**CITY OF SAN DIEGO  
M E M O R A N D U M  
As-Graded Review**

SUBJECT: Fairmount Avenue and Aldine Drive Slope and Drainage

**Subject Areas on Fairmount Avenue and Aldine Drive**

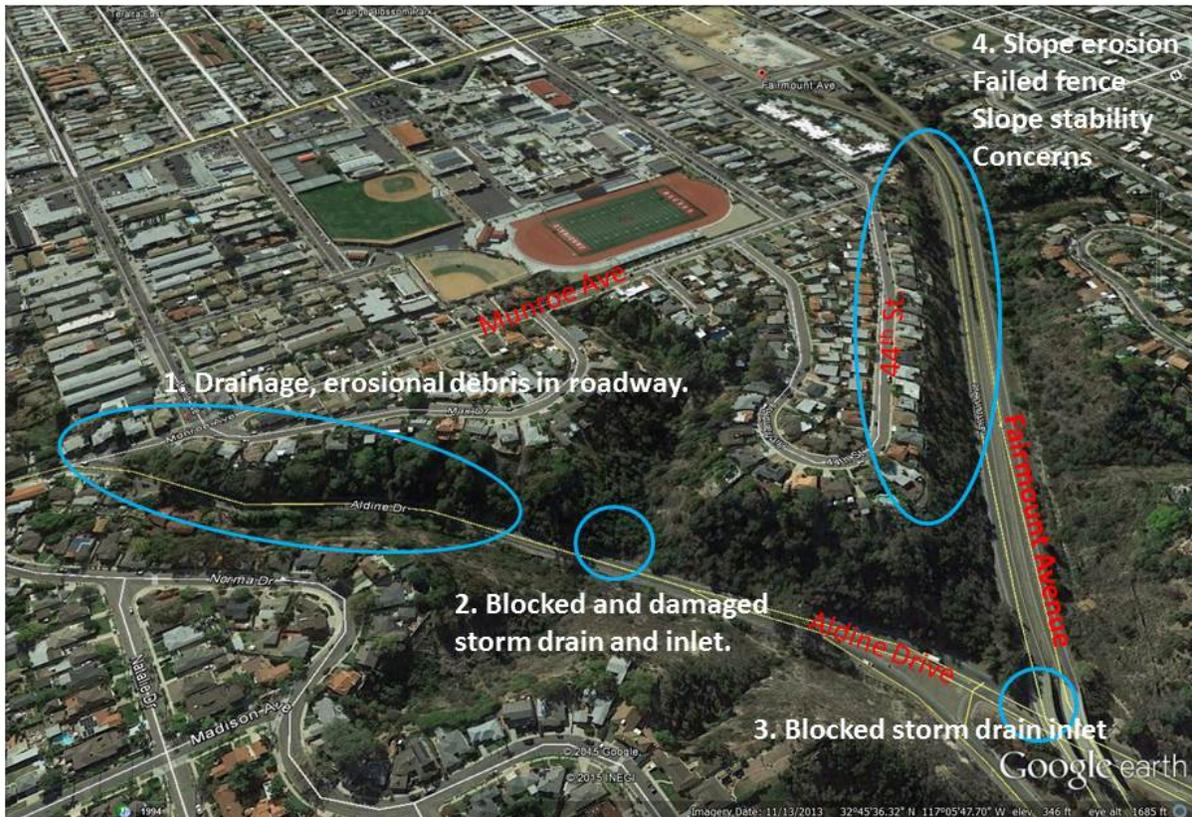
We began our tour of the affected areas at the intersection of Monroe Avenue and Aldine Drive. The drainage of the intersection is controlled by formed asphalt curbs which are reportedly overtopped during heavy rain, especially near the intersection. Continuing down Aldine toward Fairmount, Mr. Moty pointed out that cobbles and debris eroded from the slope on the uphill side roll into the travelway and can at times block the drainage and force water, rocks and soil into the lane, creating

traffic impediments. In addition, some of the drainage facilities, specifically inlets, are in need of maintenance, repair and/or replacement.

Aldine Drive: The drainage in the Right of Way should be improved by the City to accept the water runoff from the slope and adjacent streets without overtopping existing curbs. The erosion of soil and rock from the slope onto the street must be addressed by the City. These conditions should be referred to the City's Transportation and Stormwater Department for review and design.

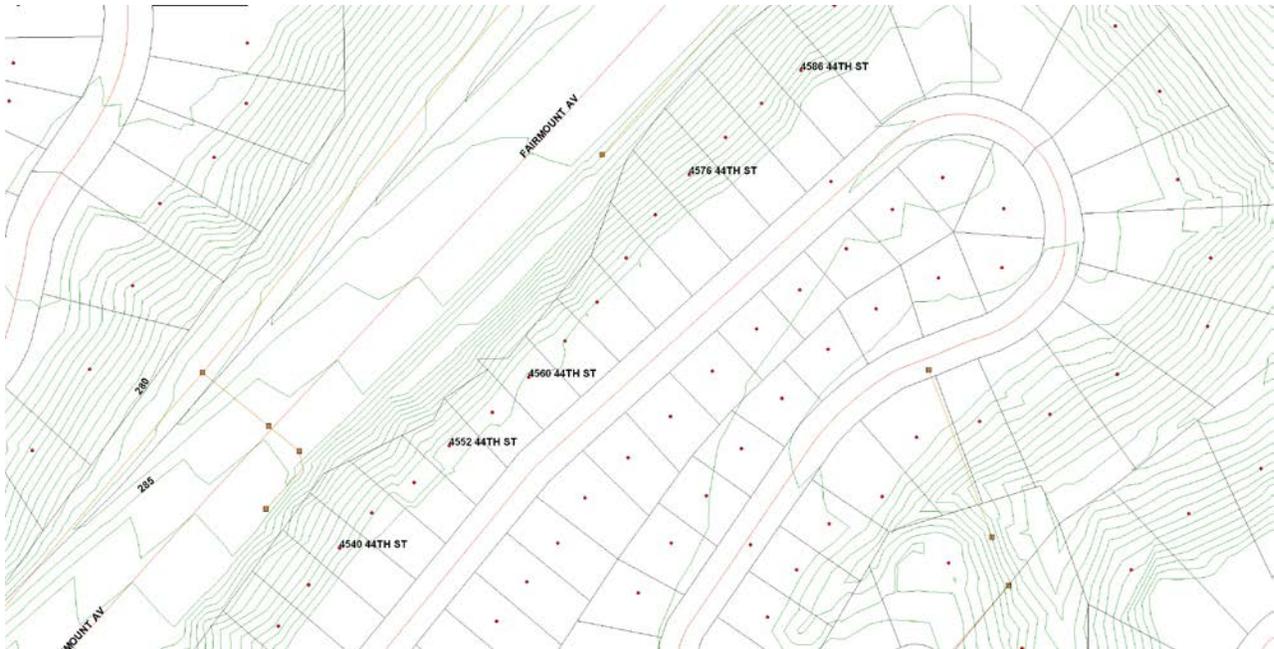
**Slopes:** The slope behind the homes was originally steep, consistent with natural slopes in the area which range from 30 to 35 degrees. Cut slopes were created in the Fairmount right-of-way at an angle much steeper than allowed under today's standards, but typical for development of the period from the 1940's to the 1960's. The lower slope on what is described as the City easement appears to be cut steeper than the rear yard slope, and is reportedly delineated by a chain link fence that was erected along the rear of the homes approximately midway up the slope. The fence was badly deteriorated, and had fallen over or been undermined along most of the alignment.

The slope appears to be grossly stable and no discernible indications of deep seated instability or landslides were observed. However, surficial stability and erosion appear to be problematic and significant evidence of shallow surface failures and erosion on the private property was observed on several properties. Erosion is a function of gravity, slope angle, types of earth materials, types and density of vegetation, and critically, water saturation and drainage.

The earth material on the site is formational mildly cemented silty sandstone with cobble layers. This unit weathers to loose silty sand and gravel which is easily eroded unless anchored by vegetation, and is sensitive to water flow. In addition, saturated loose soil will behave like a plastic material or a viscous fluid and flow downslope. This mass wasting can remove several inches to two or three feet of soil. This phenomenon has evidently occurred in several places on the slope.

It was noted that most or all of the lots drain to the rear of the property over the slope rather than to 44<sup>th</sup> street, including drainage from the house roofs. Lot and roof drainage was directed to the rear yard and over the slope rather than to 44<sup>th</sup> Street, which was not standard at the time and may have been changed since development occurred.

Fairmount Avenue: All drainage from runoff on private property should be collected and redirected away from the slope where possible, either onto 44<sup>th</sup> street or into a drain system and conveyed to Fairmount Avenue to an approved drainage facility. This will require an encroachment permit into the right-of-way by the property owners. Guttering should be installed to collect roof runoff and convey it to the street. Irrigation of slopes should be minimal and only sufficient to maintain vegetation cover. The slopes should be landscaped with drought-tolerant, deep-rooted shrubs as recommended by a landscape architect to improve surficial slope stability by anchoring surface soil.

The current fence has failed and should be removed. Replacement of the fence is at the discretion of the Transportation and Stormwater Department. It is unclear whether or not a fence is required as a barrier between Fairmount Avenue and the private property. The fence provides no positive or negative benefit with respect to slope stability.
